LOCATION OF WORK: 243 Spring St. - Spring St. Tavern

RE: 241 Spring Street

BUILDING PERMIT REPORT

241 Spring St.

FILE ESCAPE 2-11 SPRING ST.

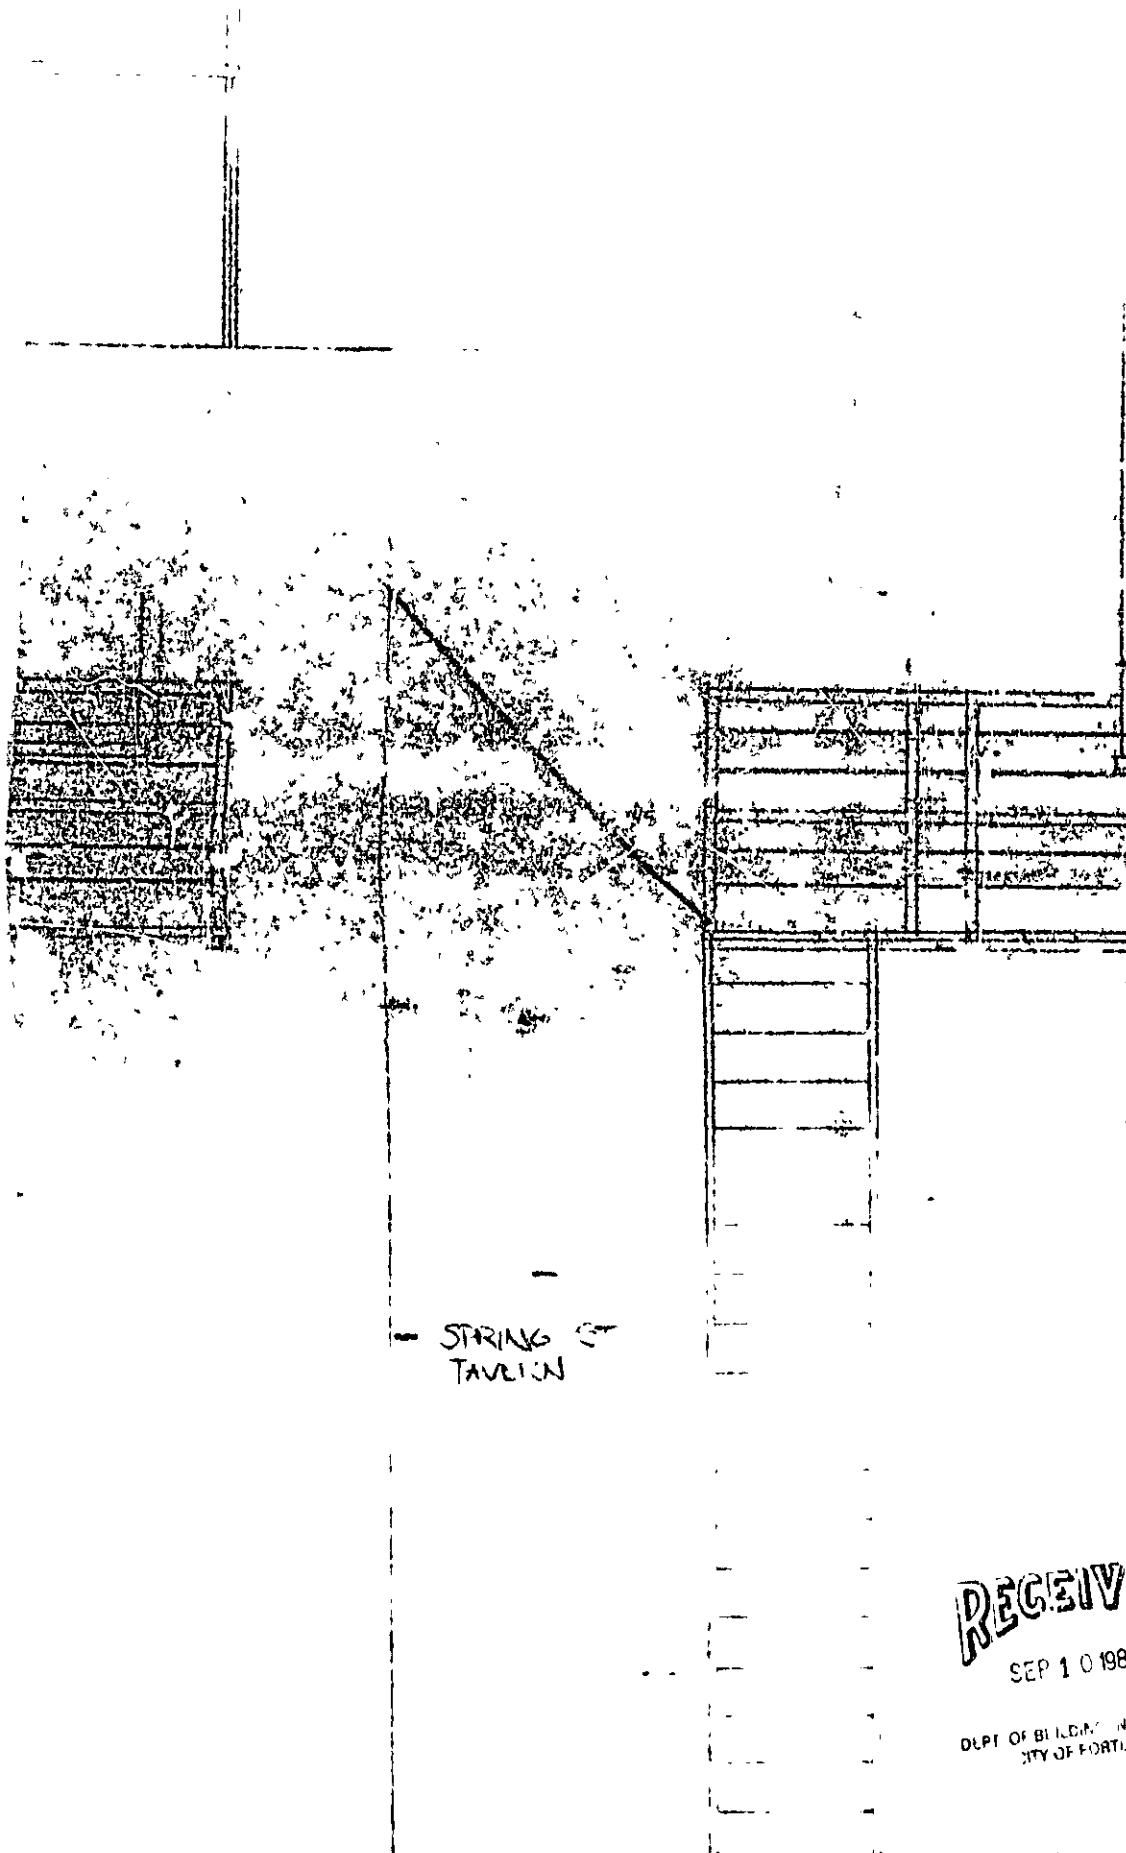
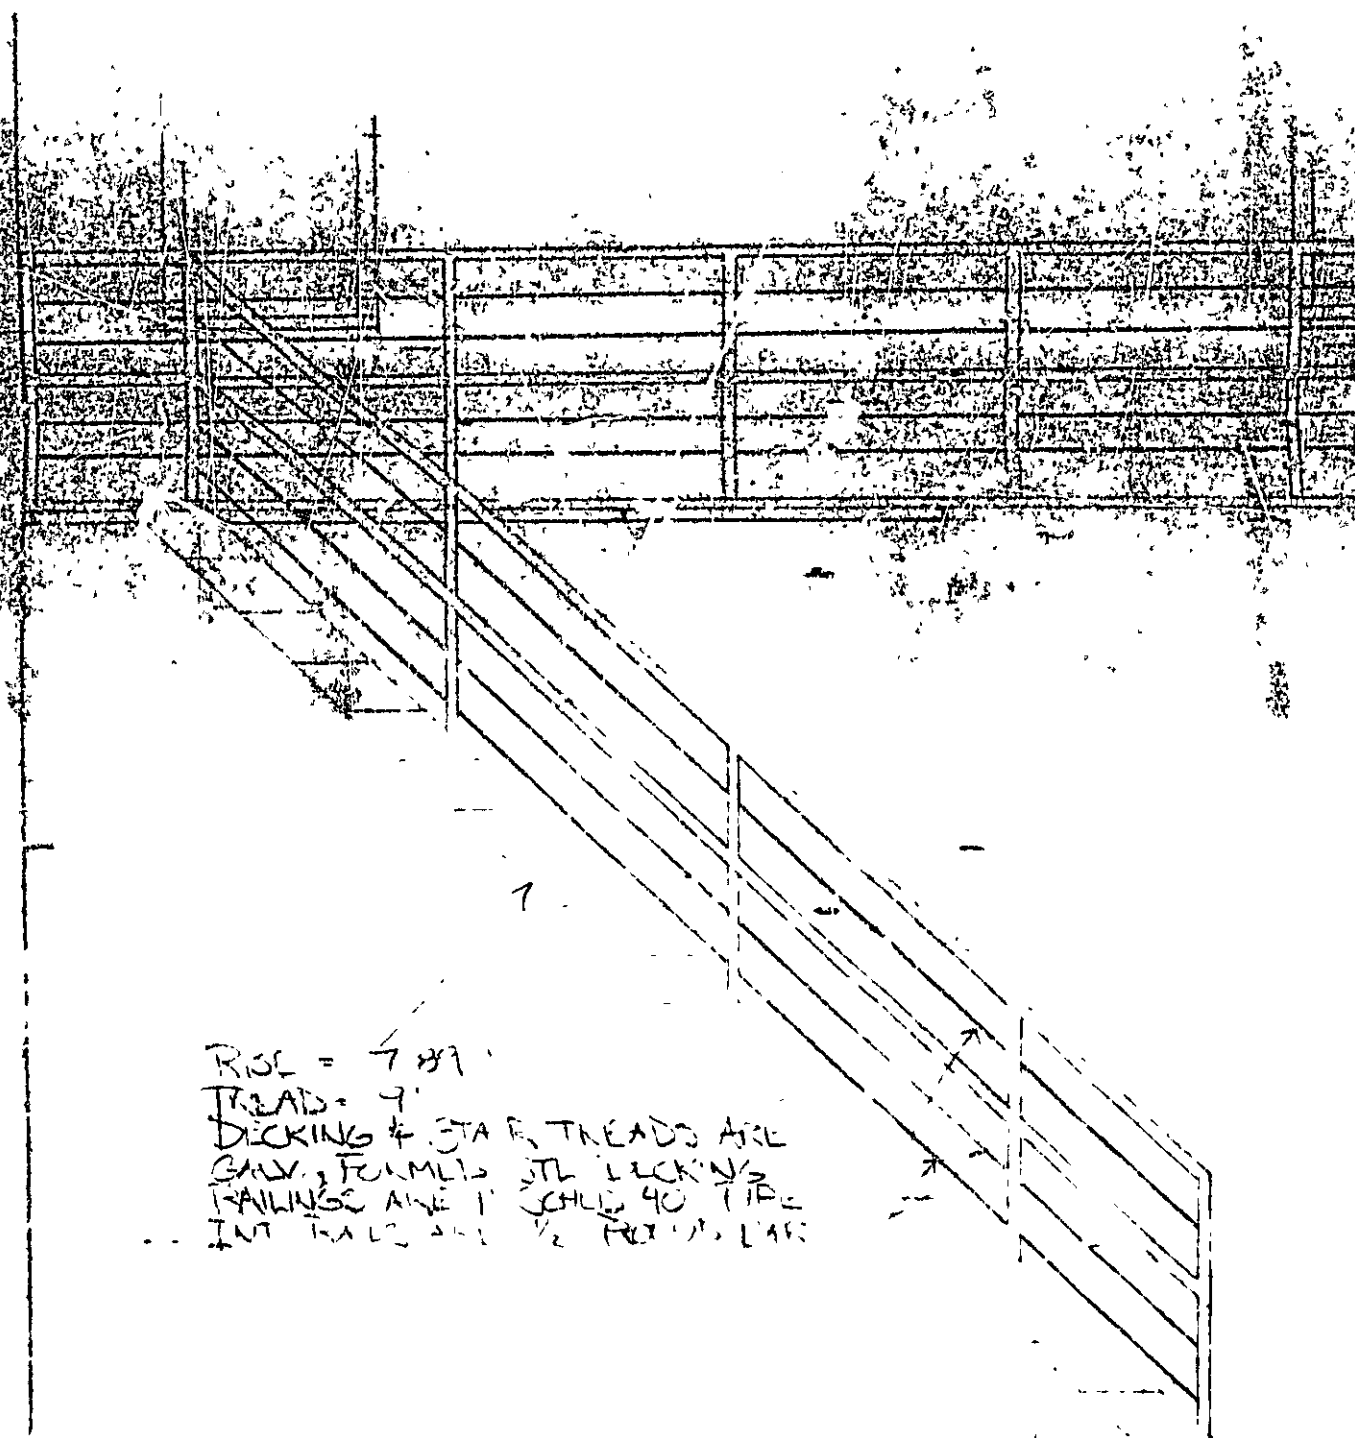
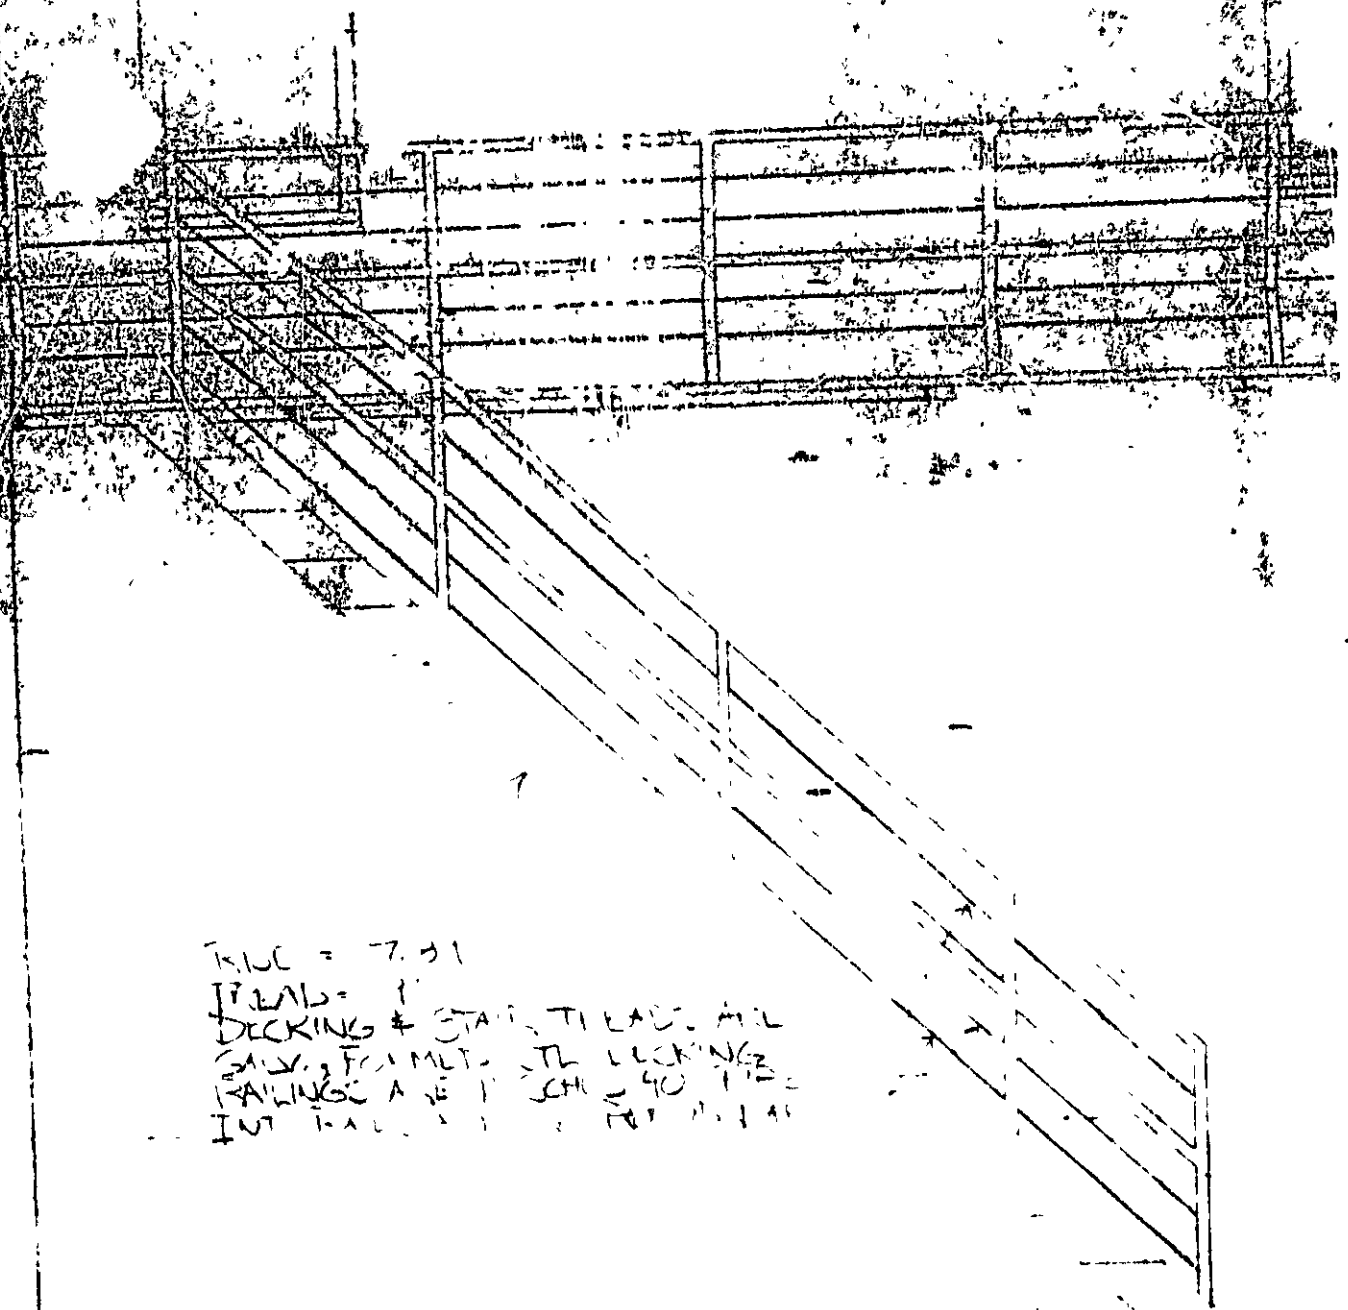
Would you please supply this office with a statement of design on your new fire escape.

The building code requires that a fire escape shall be designed to support a live load of one hundred (100) pounds per square foot.

10-8-85, Paul at the fire escape
is up on the second floor landing.
12-5-85 This escape has to be
painted but it looks OK. All
additional reinforcing plates
are in place with bolts. Bolts
attached to both sides of
the boundaries.

FRONT APARTMENT FIRST
FLOOR, 241 SPRING ST.

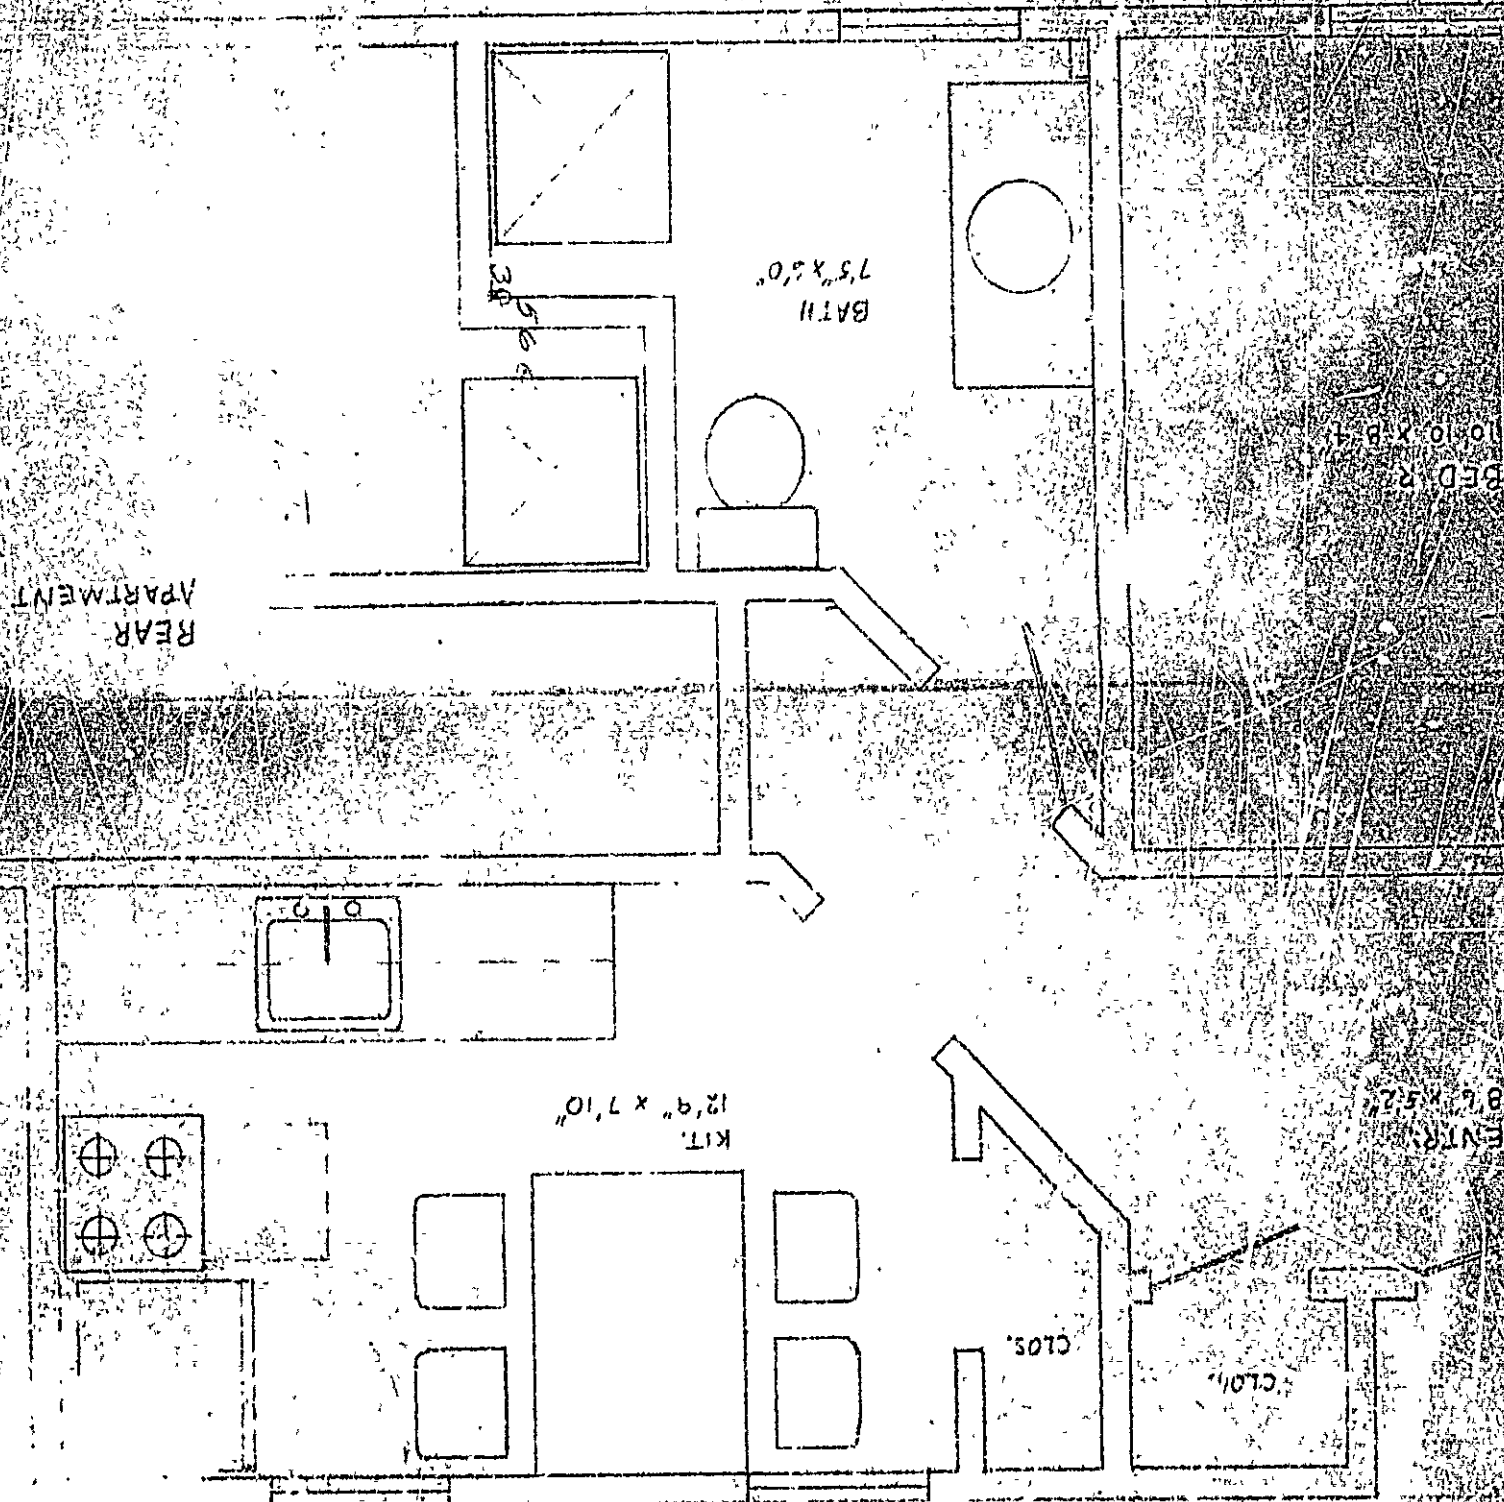
- *1.) All vertical openings shall be enclosed with construction having a fire rating of at least one (1) hour, including fire doors with self-closers.

- *2.) Each apartment shall have access to two (2) separate, remote and approved means of egress. A single exit is acceptable when it exits directly from the apartment to the building exterior with no communications to other apartment units.

- *3.) Each apartment shall be equipped with an approved single station smoke detector powered by the house current. The detector shall be located in an area which will provide protection for the sleeping areas.

- *4.) The boiler shall be protected by enclosing with one (1) hour fire rated construction including fire doors and ceiling, or by placing over the boiler, two (2) residential sprinkler heads supplied from the domestic water.

- *5.) Every sleeping room below the fourth story in buildings of Use Groups R and I-1 shall have at least one operable window or exterior door approved for emergency egress or rescue. The units must be operable from the inside opening without the use of separate tools. Where windows are provided as a means of egress or rescue, they shall have a sill height not more than 44 inches (1118 mm) above the floor. All egress or rescue windows from sleeping rooms must have minimum net clear openings of 5.7 square feet (0.53m²). The minimum net clear opening height dimension shall be 24 inches (610 mm). The minimum net clear opening width dimension shall be 20 inches (508 mm).
